ADDENDUM #1

- A. Project Number: 2018-10259
- B. Project Title: Spokane Falls Station
- C. Project Location: Spokane Falls Community College
3410 W. Fort George Wright Dr., Spokane, WA
- D. Agency: Spokane Transit Authority

<p>SPOKANE FALLS STATION 2018-10259</p>	 <p>10 N. Polk Street, Suite 500 Spokane, WA 99201 ph 509.328.3994 fax 509.328.3999 coffman.com LASTING creativity results relationships</p>	ADDENDUM # 1			
		DATE 2/15/19	DRAWN BLW	DWG. NO. CC-06	JOB NO. 2018-10259
DESCRIPTION REMOVE EXISTING DRYWELL

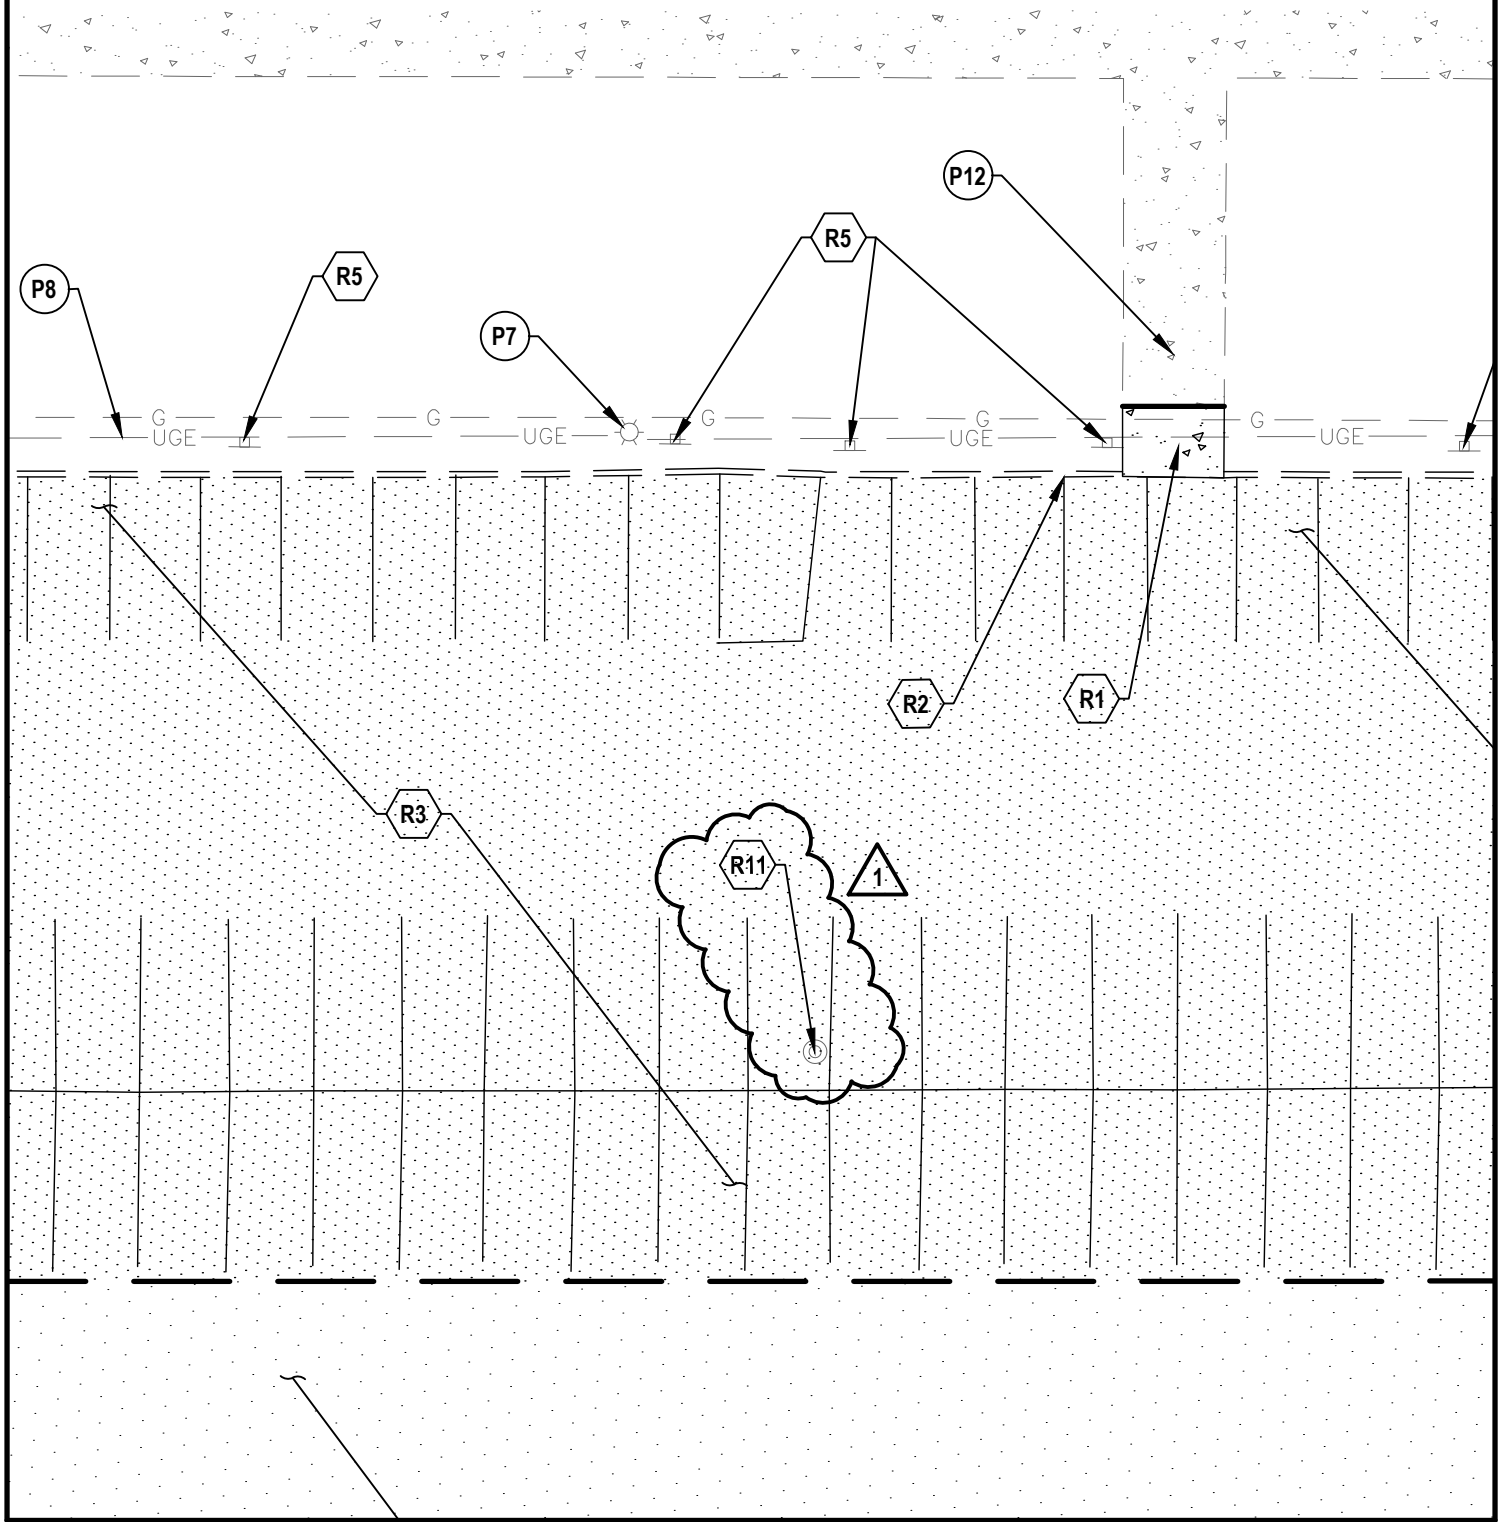
- I. **Sheet C-302 –**
Revised callout to R11 – “REMOVE STORMWATER UTILITIES”. See attached DWG NO. CC-06.
 - J. **Sheet C-042 –**
Added curb inlet, see attached DWG NO. CC-07.
